First Amendment to the Draft EIR

# Avenues: The World School Campus Project

File No. CP19-013

FIGURE 2.2-6

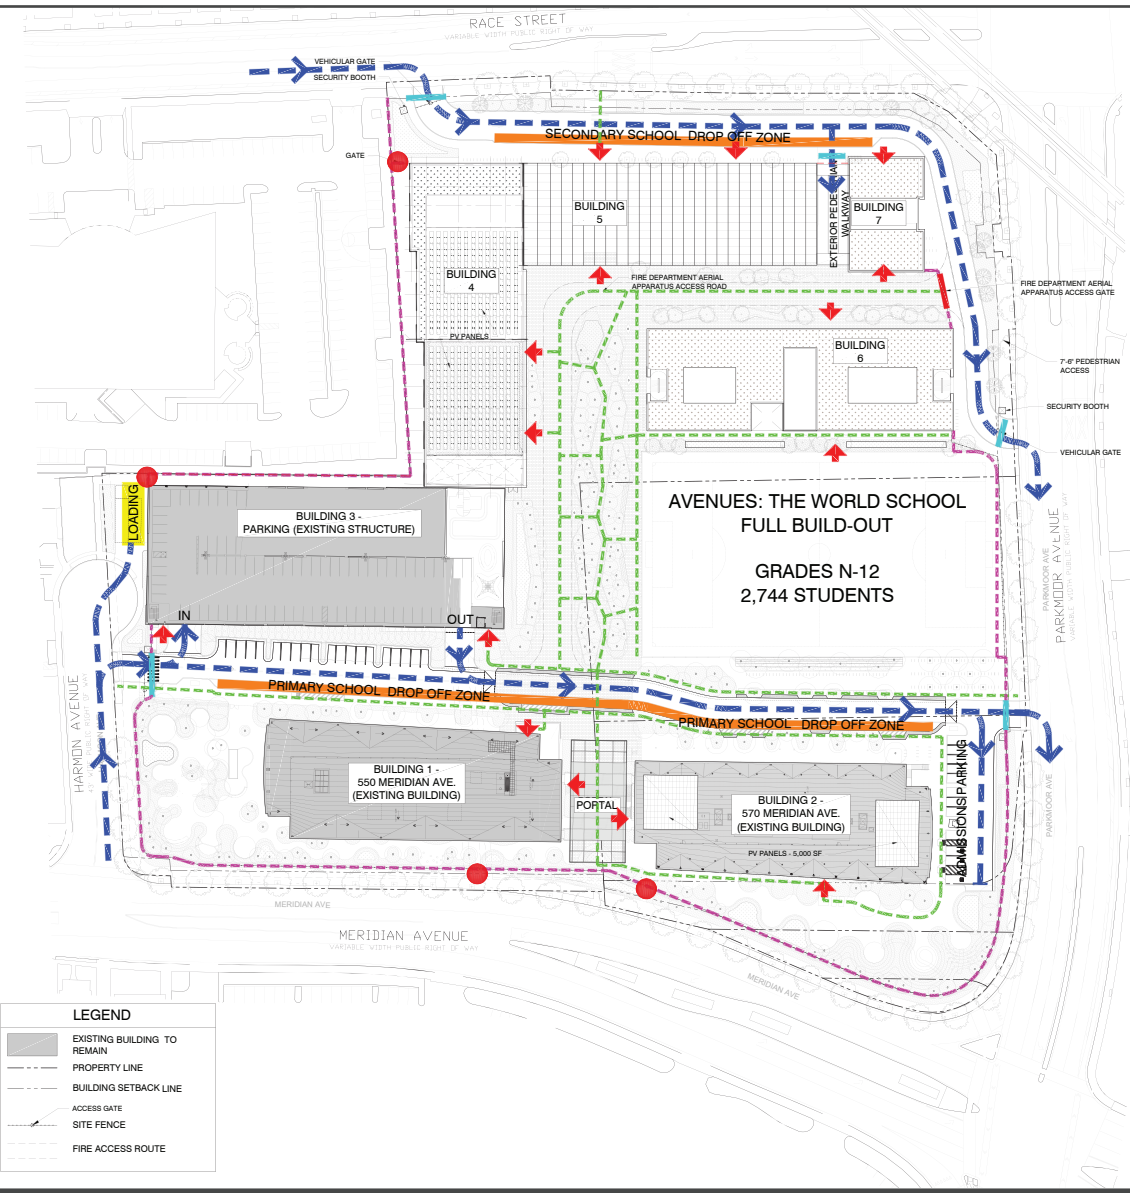
**Comment E.2:** There appears to be inconsistent information presented in the DEIR Section 2.2.3 Site Access and Circulation Site Access, Parking and Circulation in the Appendix H Traffic report. It is unclear where pedestrian and bicycle entrances will be located on the site plan. VTA recommends updating the site plan in the DEIR to document the location of the three pedestrian and bicycle gates discussed in Appendix H (p. 58). Entrances to the school for all modes of access should be clearly documented and understood.

Page 10 and 11 Figure 2.2-6 Building Height Diagram and Figure 2.2-7 Site Access and Circulation will be **REVISED** as follows:

**Response E.2:** The updated Circulation Diagram showing the pedestrian and bicycle gates is included in *Section 5.0 Draft EIR Text Revisions*.

Figure 1  
Phase 1A Circulation/Operation Plan

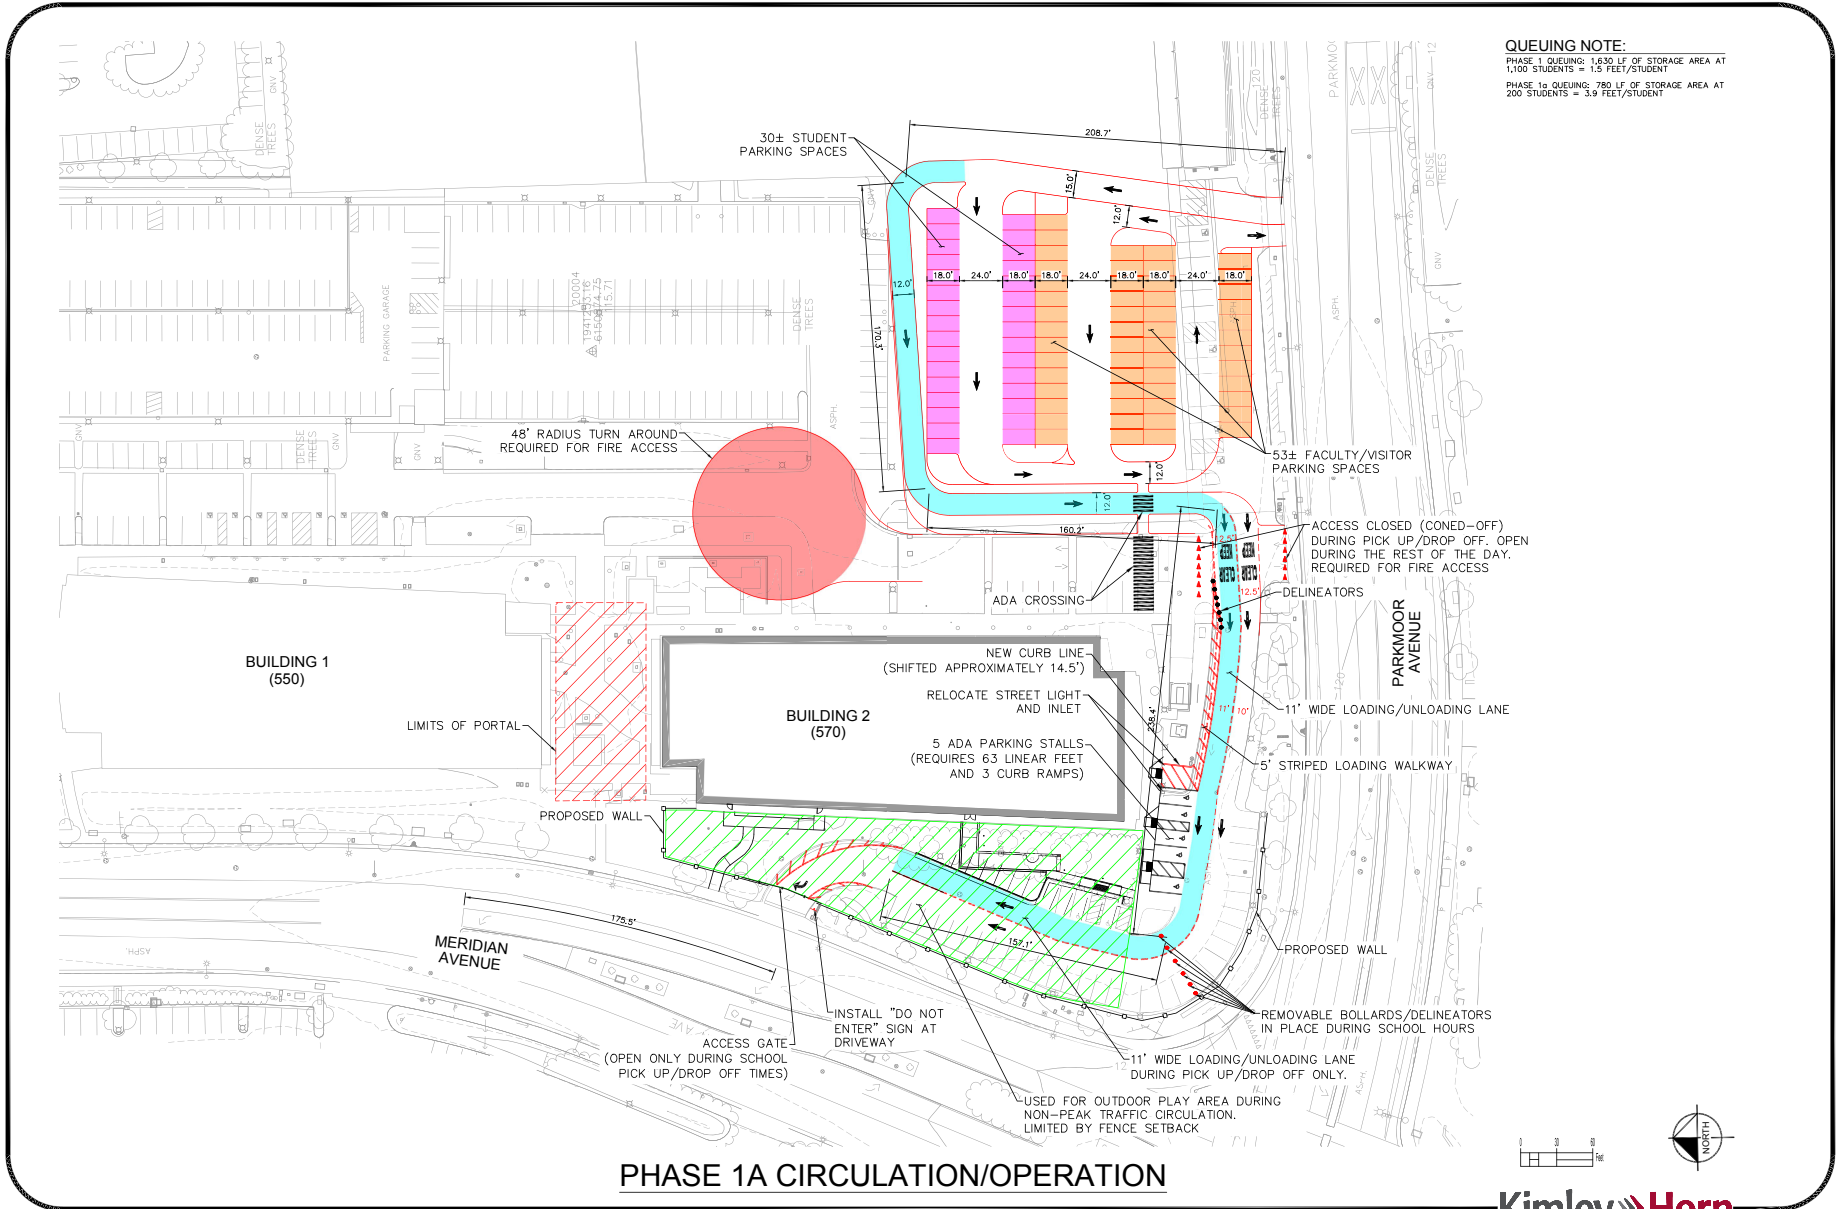
Site access to the project would be provided via a right-in-right-out driveway on Parkmoor Avenue and a right-out only driveway on Meridian Avenue. Parents and staff would all access the project site via the Parkmoor Avenue driveway. Staff or parents who park in the parking lot would exit the site via the driveway on Parkmoor Avenue. The majority of parents who access the drop-off/pick-up area would exit the site via the Meridian Avenue driveway. There would be no collapsible bollards within the public right-of-way. To ensure that vehicles do not turn left into the project site from eastbound Parkmoor Avenue, Hexagon recommends that the school clearly communicates the expectation with parents and enforces it by having a staff member present at the driveway. The fire access lane would be coned off during drop-off/pick-up periods and would be open for the rest of the day. A security gate would be located at the driveway exit on Meridian Avenue. The gate would remain open during peak hours of operation. The circulation/operation plan is shown on Figure 1.
